AXC F 2152 – CHANGE NOTES

Change notes for the AXC F 2152 controller

Application note
108427_en_07

Current firmware version: 2019.3

Figure 2 Select Trigger task

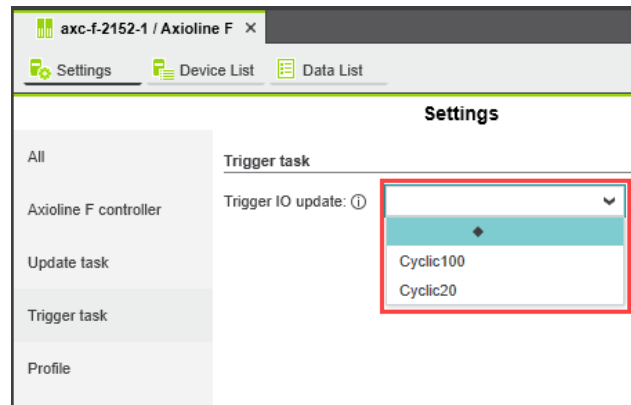
You can now specify the refresh interval for Axioline F I/O data. This is done by selecting which task triggers the Axioline F I/O data update in the PLCnext Engineer project.

- Select the “Trigger task” view in the “Settings” editor.
- In the drop-down list, select the task that is to trigger the Axioline F I/O data update.

If you do not select a task, the update will occur by default every 50 ms.

Figure 3 Monitor time

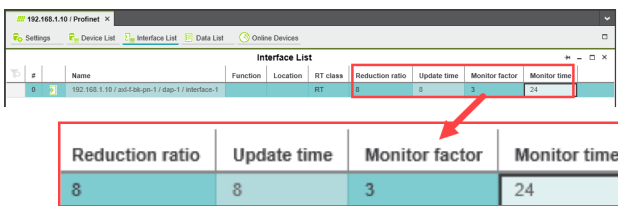
- Monitor time of PROFINET data
The PROFINET data monitor time must be at least 24 ms. The monitor time is the product of „Reduction ratio“ and „Monitor factor“ (in PLCnext Engineer: „Profinet“ editor group, „Interface list“ editor).
